Access Compliance Report

Public Rights-of-Way

Intersection ID: 10019902	Main Street: ARCO_CORPORATE_DR	Cross Street: N/A	Location: NE
ADA ID: 75EA40C0CAF2	Ramp Type: PerpDiag	Initial Pass/Fail: Fail	Overall Compliance: No
Severity Score: 21.25			
Codes/Mitigation Info/Possible Solution		Field Measurements/Component Compliance

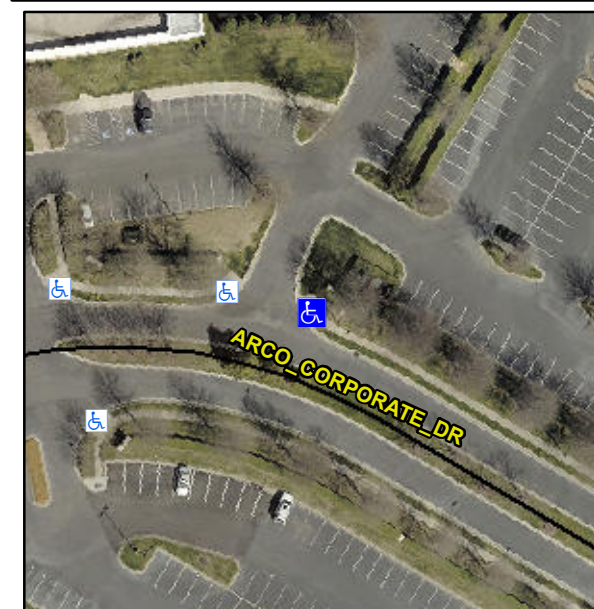
R304.5.1, R304.2.2

Compliance	Description	Data	Compliance	Description	Data
N/A	Ramp Length (in)	47.0	No	Ramp Slope (%)	9.8
No	Ramp Width (in)	36.0	Yes	Ramp XSlope (%)	1.8
N/A	Flare Type LT	N/A	N/A	Flare Type RT	N/A
N/A	Flare Slope LT (%)	N/A	N/A	Flare Slope RT (%)	N/A
N/A	Flare Traversable LT?	N/A	N/A	Flare Traversable RT?	N/A
N/A	Landing Length (in)	N/A	N/A	DWS Provided?	N/A
N/A	Landing Width (in)	N/A	N/A	DWS Contrast?	N/A
N/A	Landing Slope (%)	N/A	N/A	DWS Length (in)	N/A
N/A	Landing X Slope (%)	N/A	N/A	DWS Full Width?	N/A
N/A	Landing Curb? (Y/N)	N/A	N/A	DWS Offset (in)	N/A
N/A	Shared Landing?	N/A			
N/A	Gutter Ponding?	N/A	N/A	Gutter Slope (%)	N/A
N/A	Gutter Lip Ht (in)	N/A	N/A	Gutter X Slope (%)	N/A
N/A	Painted X Walk1?	No	N/A	Painted X Walk2?	No
	X Walk 1 Direction	To W		X Walk 2 Direction	To S
N/A	X Walk 1 Width (in)	N/A	N/A	X Walk 2 Width (in)	N/A
	X Walk 1 Slope (%)	1.5		X Walk 2 Slope (%)	3.1
	X Walk 1 X Slope (%)	3.3		X Walk 2 X Slope (%)	0.6

Remove & Replace Curb Ramp With Two New Directional Ramps or Equivalent.
